HISTORIC AND DESIGN REVIEW COMMISSION

July 15, 2015

HDRC CASE NO: 2015-231
ADDRESS: 636 MISSION ST
LEGAL DESCRIPTION: NCB 2913 BLK 2 LOT N 45 FT OF 9
ZONING: RM4 H
CITY COUNCIL DIST.: 1
DISTRICT: King William Historic District
APPLICANT: Jeffrey Szarek
OWNER: Jeffrey Szarek
TYPE OF WORK: Replace concrete walkway; tree removal

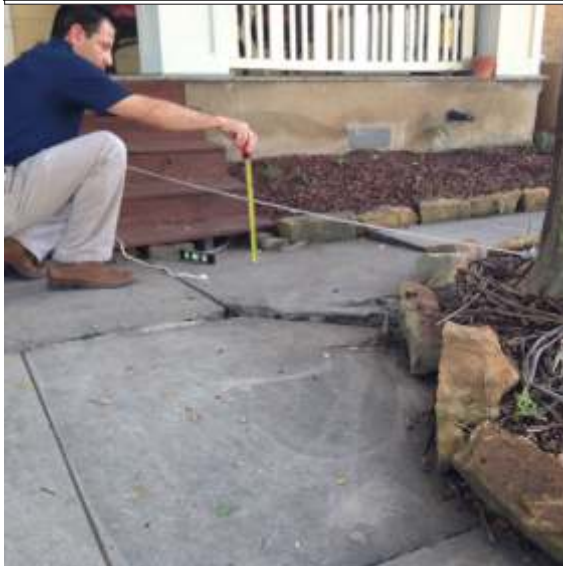
6" distance from existing side walk to highest tree root .

8" distance from existing side walk to porch steps if the side walk is extended at the same level without a decline to drain water away from home.
The 1st step would be completely covered with concrete.

14" distance from existing side walk to porch steps if the side walk is poured with a decline to divert water away from the home.
The 1st and second steps would be completely covered with concrete

Close up photo of side walk

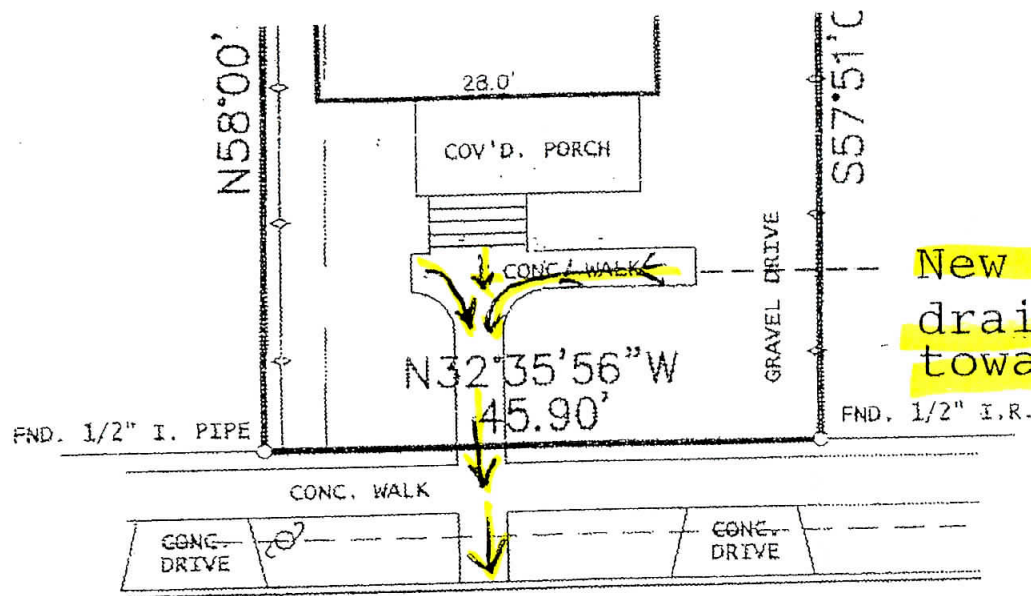
Other view with side walk at decline to divert water away form home

3" decline from top of existing side walk to bottom of existing side walk at area closest to home
